July 28, 2016

NOTICE OF ADDENDUM ADDENDUM 1

CONTRACT NO. 7347 - FIRE STATION 3 – ROOF REPLACEMENT

SP-3KB

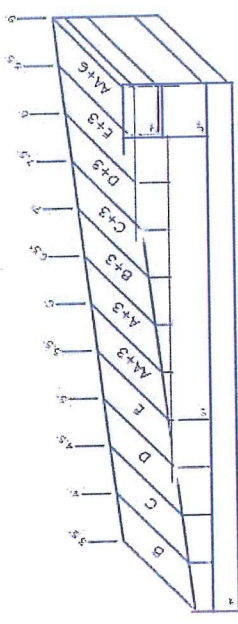
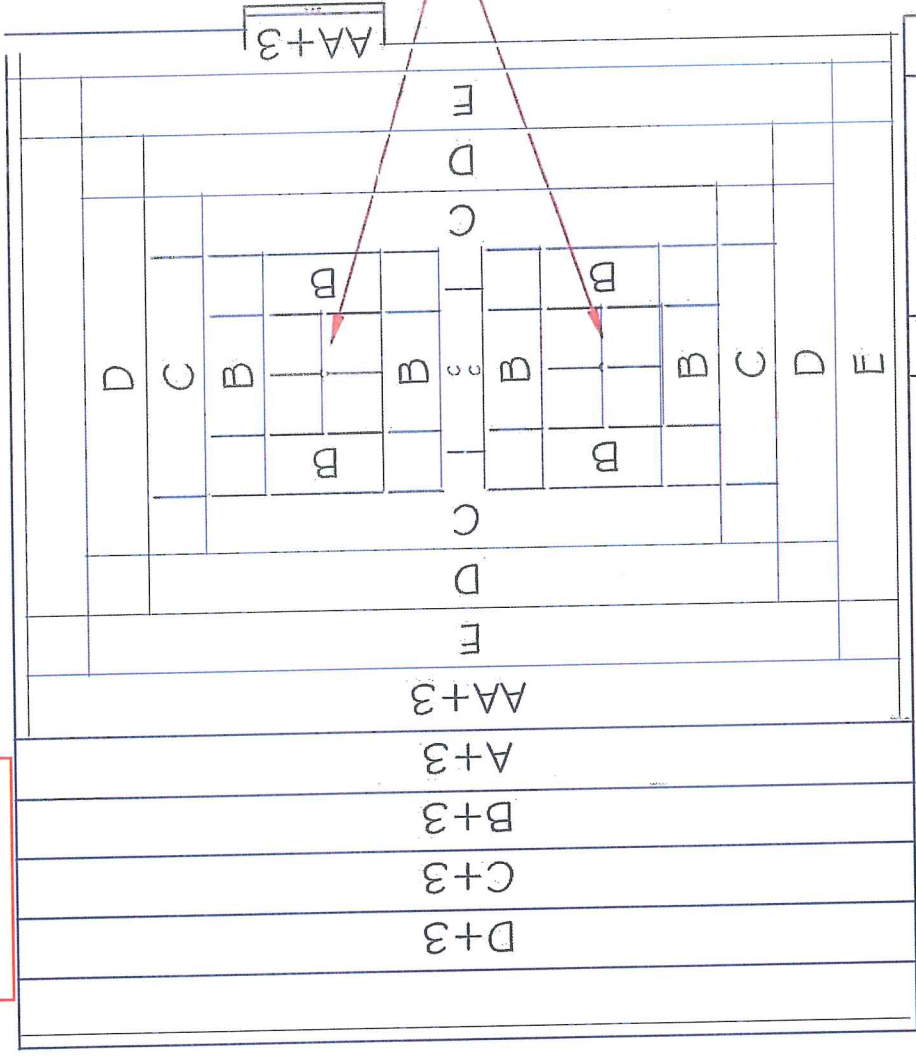
- B. See revised Spec Products SP-3KB tapered insulation drawing dated 7/8/2016.
- C. See revised perimeter termination drawing PT-1KW dated 7/24/2014 - “Termination with Reglet Counter flashing and Termination Bar” and note that this shall terminate as shown with a sealant joint just under the cap stone which will match the height of the existing termination.
